Date: January 13, 2026 Case Number: ZC-25-183

## Zoning Map Amendment

**Site Location:** 11661 Alta Vista Road

### Site Plan Comments

DRAWN BY: jsq lic. 1146 juliojaimesa@yahoo.com 817-264-1907	
CHECKED BY:	
DATE:	12-10-25.
r e v i s i o n s	
	R E V I S I O N S
SHEET	
C-1	
2	
10

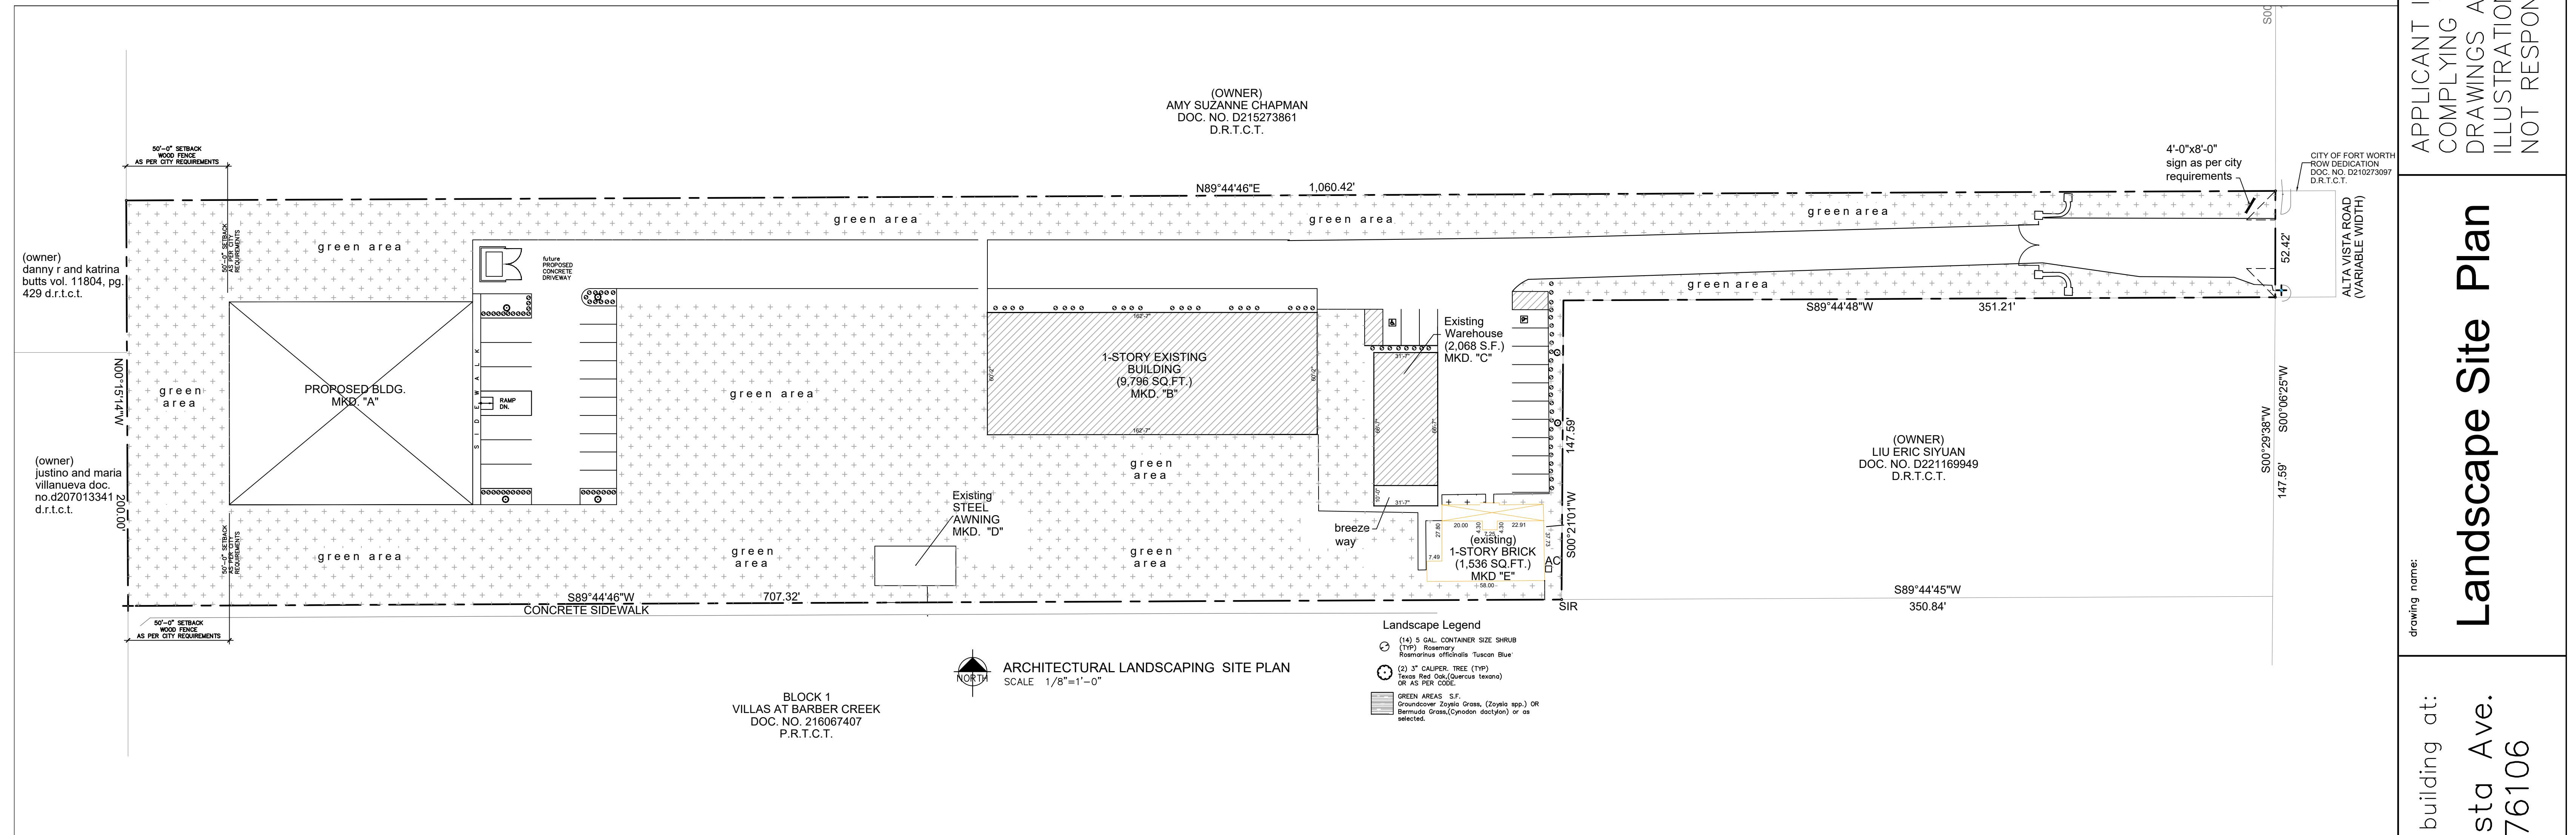
The site plan on Sheet C-1 as submitted is not in general compliance with the Zoning Ordinance regulations. If approved, these comments would need to be addressed prior to ordinance adoption.

1. Add the metes & bounds legal description to the site plan.
2. Add the name, address, and telephone number of the developer/owner and applicant to the main site plan, instead of the title sheet.

3. Add a vicinity map to the main site plan, instead of the title sheet, and graphic scale since the PDF will be viewed as different scales.
4. Provide a signature line labeled: "Director of Development Services" with a "Date" line above the project title to the main site plan, instead of the title sheet.

5. Add the office building to the chart that notes the specific land use of each building, number of stories, height, exterior materials, and gross floor area.

6. Move the ADA space to be closest to the front door of the office.
7. Create a surface materials legend and add these colors/patterns to the main site plan. Include the surface materials of all ground level areas, including the driveway/parking materials and open spaces (instead of green area). Add this information to the main site plan, instead of a separate landscaping page.

9. Building "C" is mis-labeled on sheet A-7.
10. Show the parking calculations to include the formulas for both 2 spaces/1,000 square feet of gross floor area for the stone cutting area or 1 space/3 employees. The greater number of parking spaces is required for industrial uses. The rough calculations are 20 parking spaces are required for 9,796 square feet of floor area. If fewer parking spaces than required are shown and approved, add the note in bold: "**A development waiver was granted to provide XX fewer parking spaces than required.**"

11. Show the parking calculations for the warehousing space at 1 space per 4 employees, with 4 spaces minimum. Show the parking calculations for the office at 2.5 spaces/1,000 square feet of gross floor area.

12. Show the parking calculations for the office uses at 1 space for each 400 square feet.
13. Please label the front gate and note its height and building materials. Add the note that the gate was existing at time of annexation.

14. Show and label the driveway width at the front property line and the widest width.
15. Label the materials of the dumpster enclosure.
16. Label the land use and zoning classifications of the surrounding properties in all directions, as well as the subject site, instead of the ownership.

17. Informational comment: Signage is not allowed on fencing or gates.
18. Generally, the site plan is hard to read, as the lettering is very faint/almost ghosted. Is there a way to print the PDF where the plan information shows better?

# PERIMETER FENCE SITE PLAN

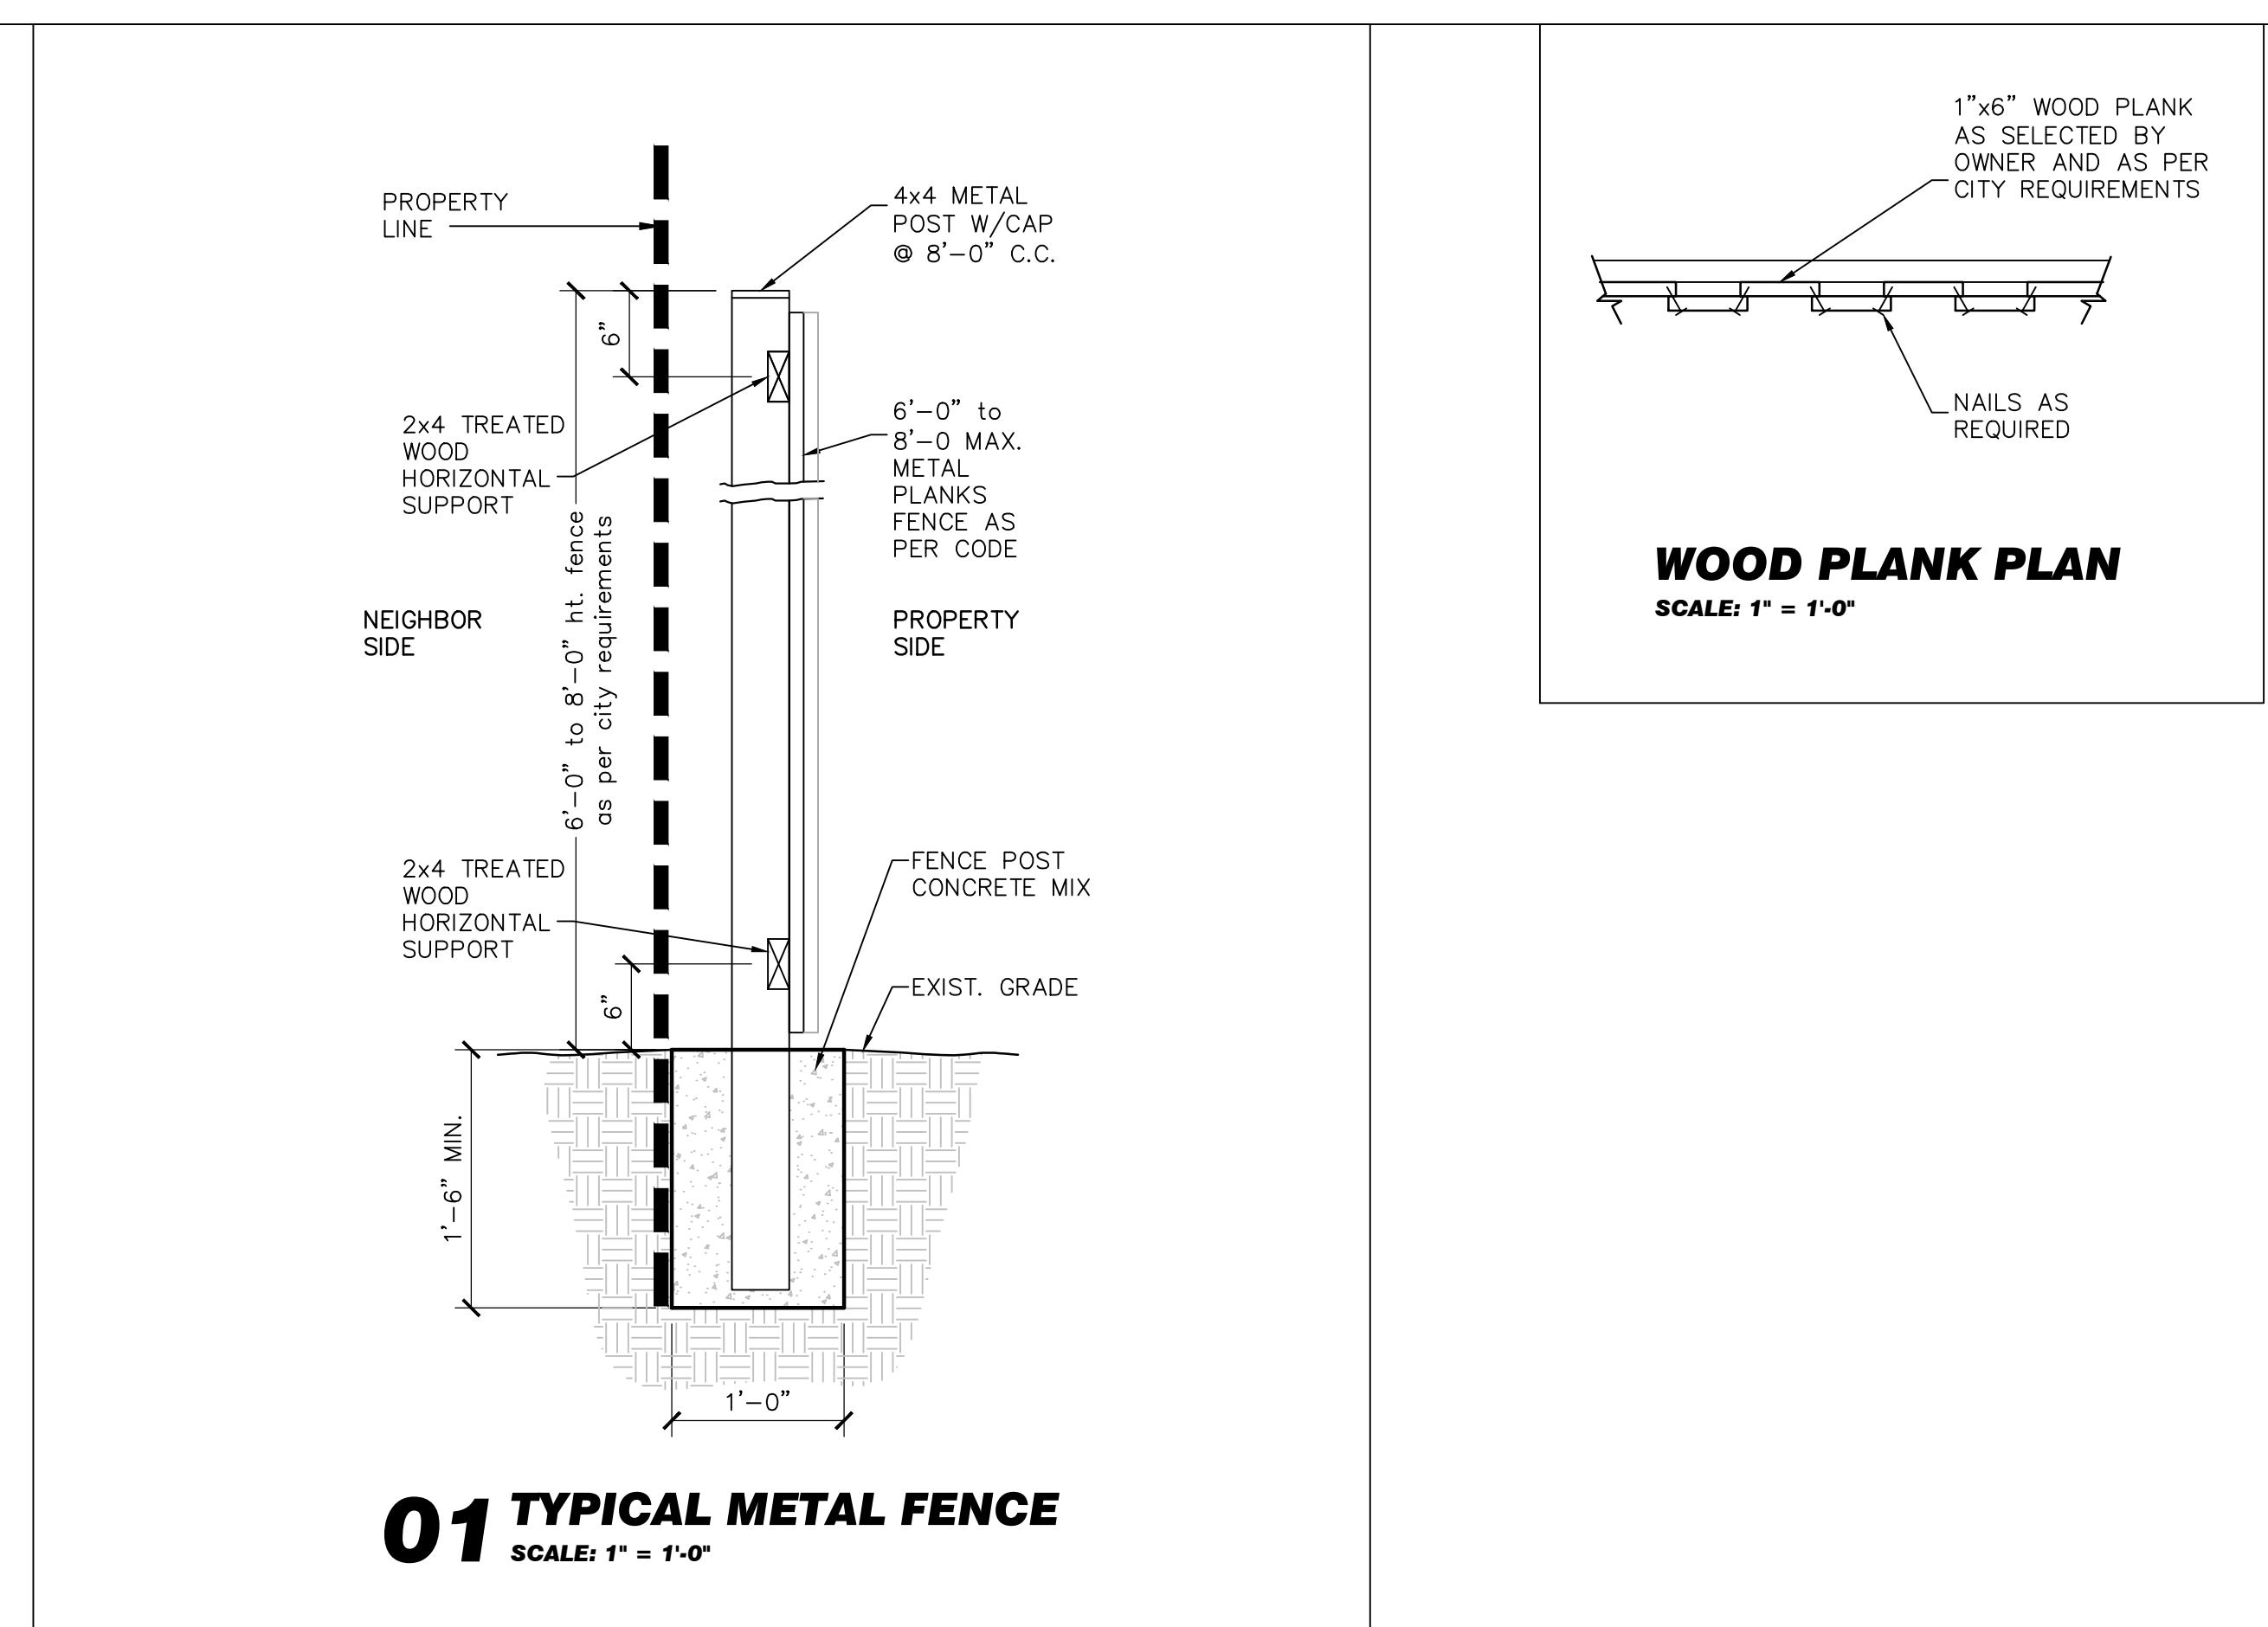
8. The fencing must be wood, stucco, brick, or stone, instead of metal panels. Revise the fence material label on the typical fence drawing to match the wood plank plan.
